APPLICATION FOR PERMIT FOR HEATING, COOKING OR POWER EQUIPMENT

AP-Island Avenue, Long Island (93-E-25)

AP Island Avenue, Long Island
(Assessors' Lot No. 93-E-25)

Subject: Building permit for conversion of
Cushing's Pavilion at Ponca's Landing, Long Isl.
to a restaurant

Heating System
for
V.F.W. Hall
Long Island

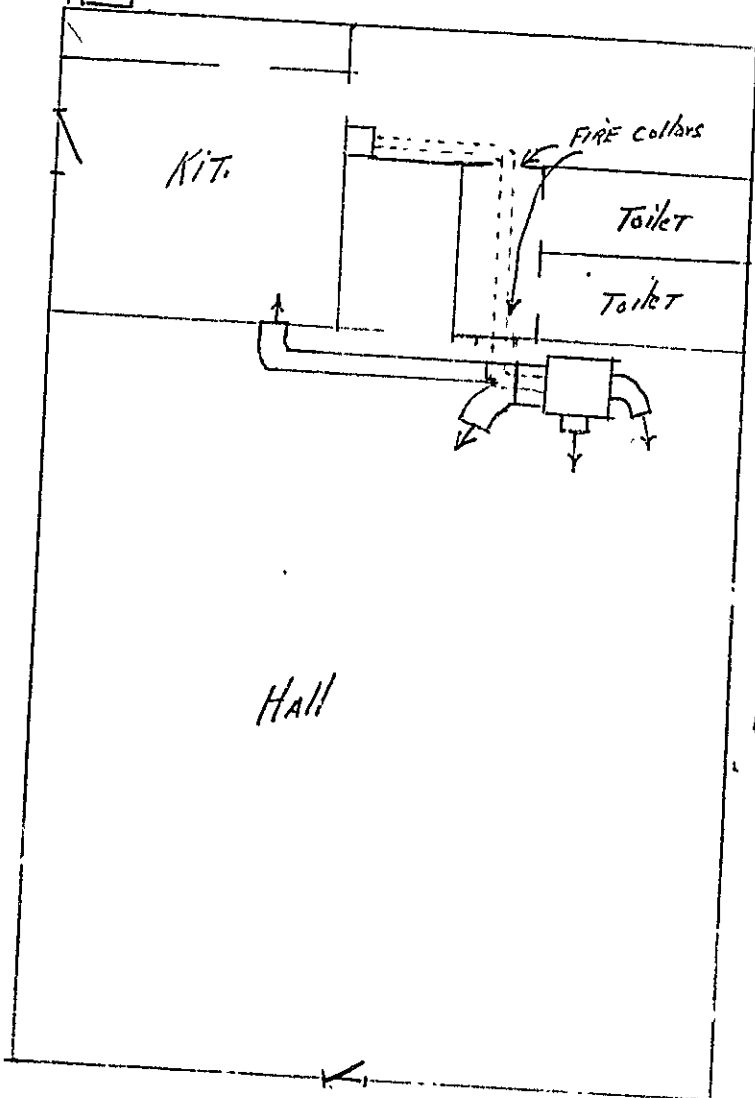
1. Permit is issued for installation on a wood floor without protection on the understanding that the fan chamber occupies the entire area beneath the firing chamber and forms a well ventilated air space between the firing chamber and the floor of not less than 18 inches in height with at least one metal baffle between the firing chamber and the floor. If this is not the case, installation is not to be started until approval of a satisfactory mounting has been secured from this department.

2. Where smokepipe from heater is to pass through a combustible partition, a metal ventilated thimble at least 12 inches larger in diameter than the pipe is to be provided.

3. Smokepipe is to be kept at least 18 inches from combustible material above and at sides of it unless shields constructed as specified in Section 602-B of the Building Code allowing lesser clearances are provided.

4. A four inch reinforced concrete slab is to be provided for support of the outside above ground fuel oil storage tank.

FLOOR PLAN OF LAMP BARN BUILDING
PONCE LANDINGS LONG ISLAND
CASCO BAY MAINE
DRAWN BY I. MCCOY 6/24/42

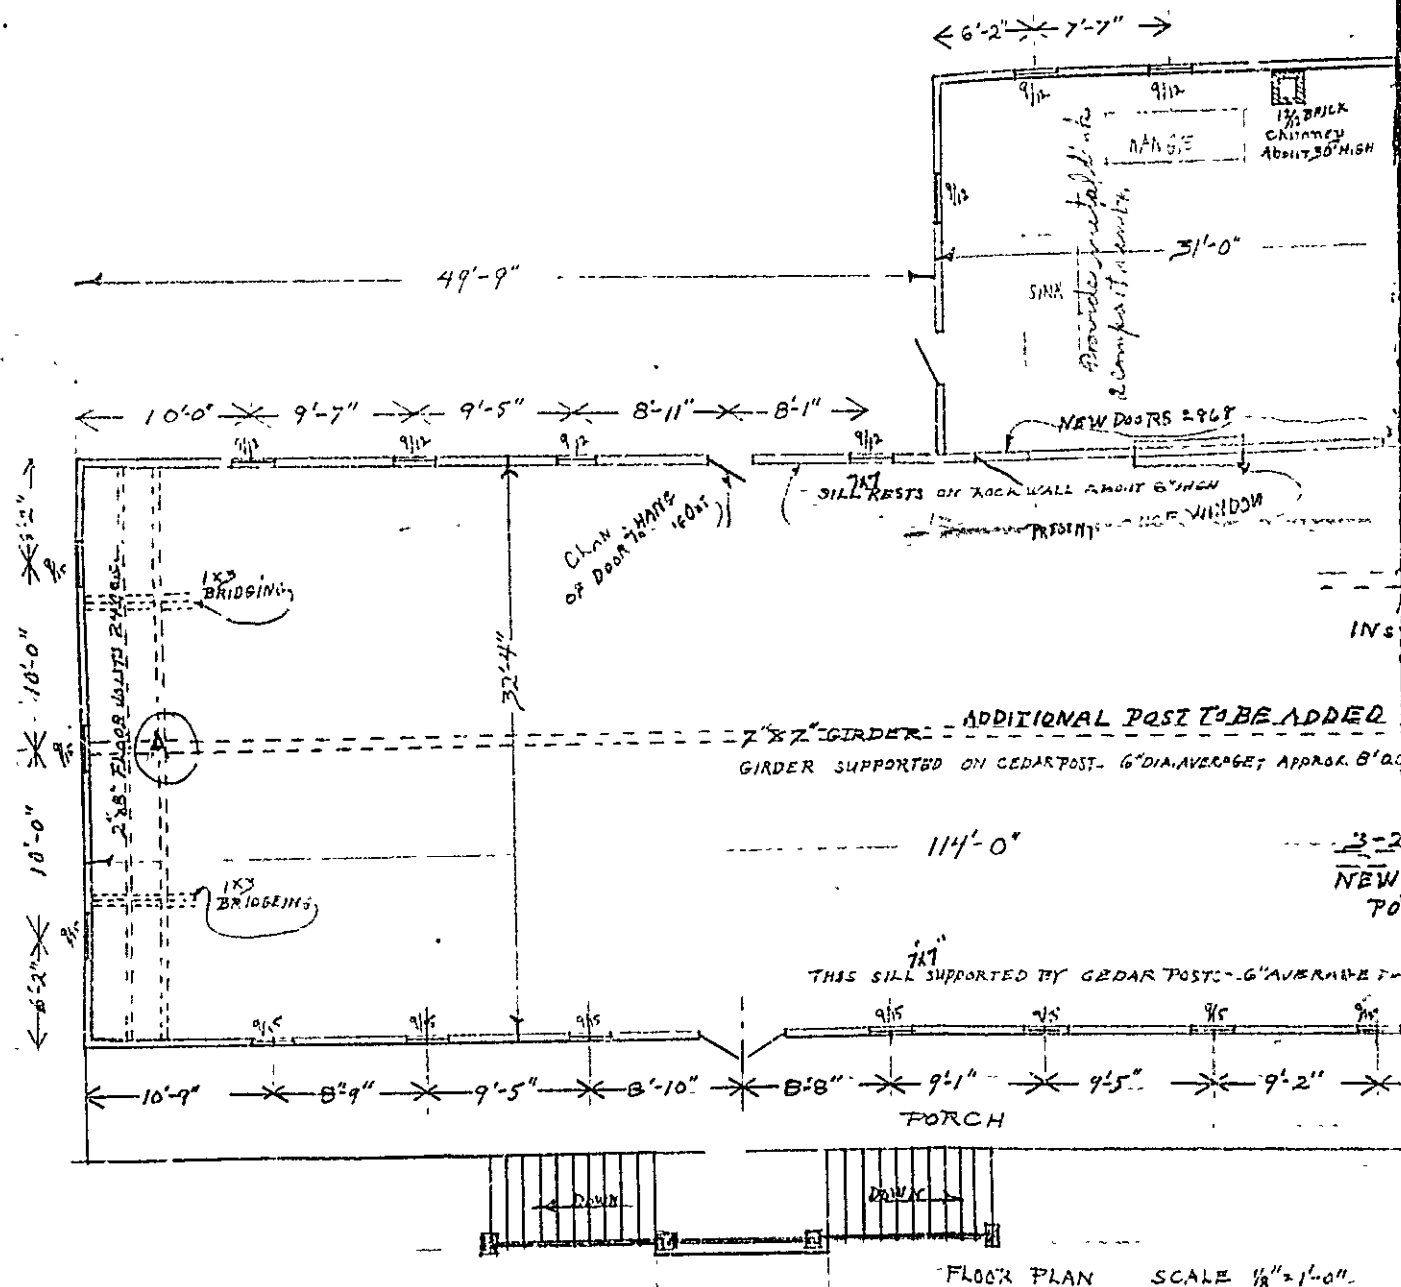
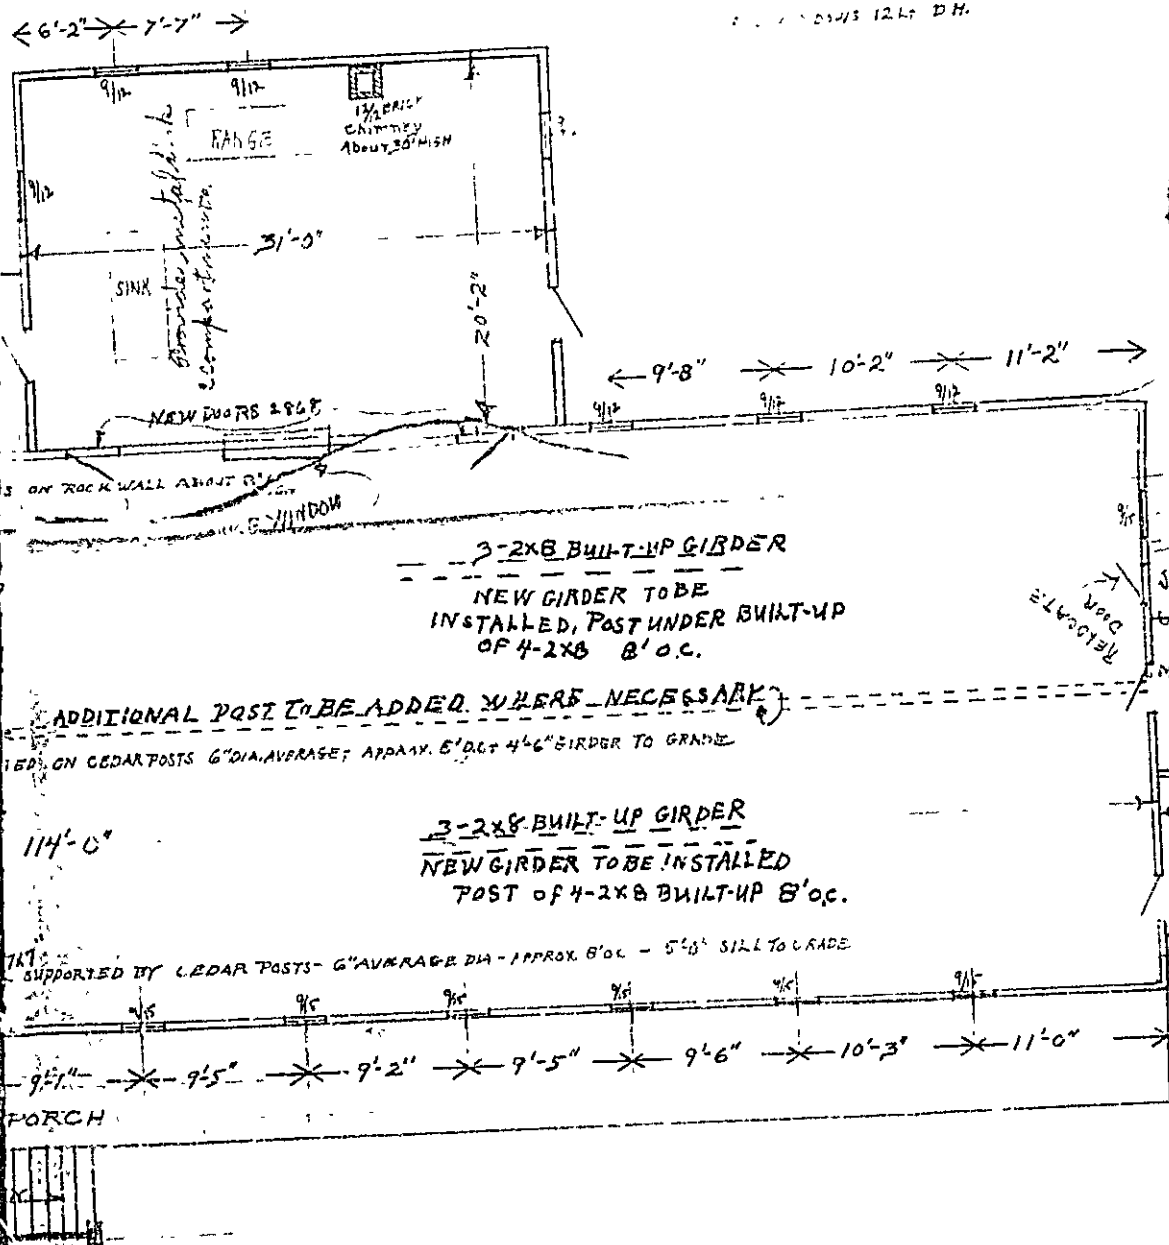
1. I understood you to say that you would come into the office and change the plan to show a line of girders on either side of the existing center girder under the floor joists, thus cutting down the span of the 2x8 joists to about eight feet instead of 16 feet, the latter being much too long. This has not been done. The 7x7 girder on spans of about eight feet existing under the centers of the floor joists does not figure out well for a 100 pound per square foot live load. Depending somewhat upon conditions, however, it is possible that we may be able to accept the existing girder as it is, provided the building is to be used as a restaurant only for the summer months and that no dancing or group games will be undertaken. The new girders to be put under the centers of the existing spans, however, must be designed to support a live load of at least 100 pounds per square foot, and it should be shown on the plan accordingly. I understand the sill under at least one side is supported upon corner posts about eight feet from center to center, but I cannot find the size of the sill. To satisfy Building Code requirements, even though we make allowance for the fact that there would be no live load on the floor when there was any snow load on the roof, the sills on an eight foot span ought to be at least 6x8 or 4x10 set with the larger dimension upright.

necessary to introduce the two additional lines of girders which you mention, and it is also likely to be necessary to introduce solid bridging in each of the floor joist spans.

3. The doors counted as a means of egress are not sufficiently separated to satisfy the requirements of the Building Code or those of the Board of Fire Engineers of which Fire Chief Sunborn is the head. It will be necessary to provide an emergency exit door in each end of the building, each door to swing out, to be no less than two feet ten inches wide and no less than six feet four inches high, each of these doors and the exit door opposite the main entrance (which is marked on the plan to be closed to swing outwards) requires anti-panic hardware and an exit light showing on the inside with letters showing red or green no less than four and one-half inches high, these lights all to be on a single circuit. Platforms and steps outside of these doors will be required consistent with the grade outside of the doorways.

4. The plan seems to indicate a single step between the level of the long porch at the main entrance and the top landing of the two way stairway. This is not permitted to be a single step, and if one exists now it will have to be adjusted so that there will be either no step at all or at least two risers. All of these stairs are required to have hand rails on both sides.

Provide handrails on both
sides of stairs to the...

Remove range & sink
at 1st floor level
